**Economic and Social Council**Distr.: General
2 August 2011

Economic Commission for Europe**Inland Transport Committee****World Forum for Harmonization of Vehicle Regulations****Working Party on General Safety Provisions****One-hundred-and-fifty-fifth session**

**1958 Agreement – Consideration of draft amendments
to existing Regulations submitted by GRSG****Proposal for the 05 series of amendments to Regulation
No. 107 (M₂ and M₃ vehicles)****Submitted by the Working Party on General Safety Provisions ***

Model A

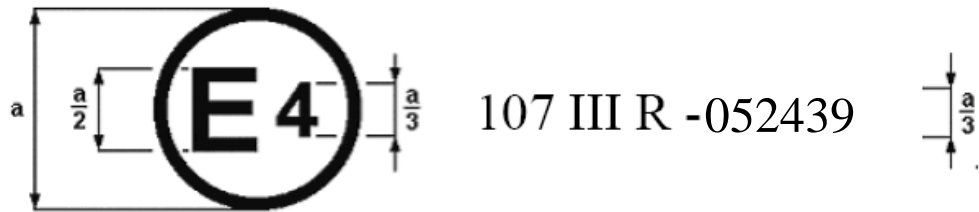
Annex 2, amend to read:

a = 8 mm min

The above approval mark ... under approval number 052439. The approval number ... as amended by the 05 series of amendments.

Model B

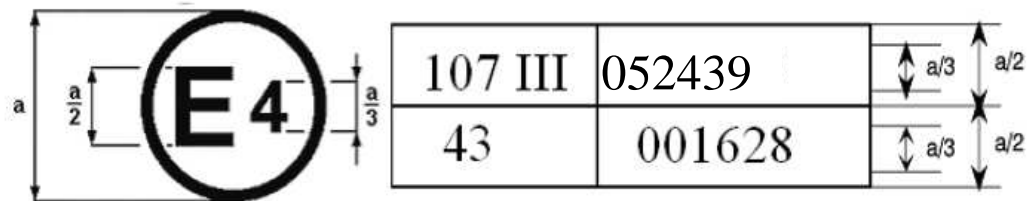
a = 8 mm min

The above approval mark ... Regulation No. 107 included the 05 series of amendments and Regulation No. 43 was in its original form.
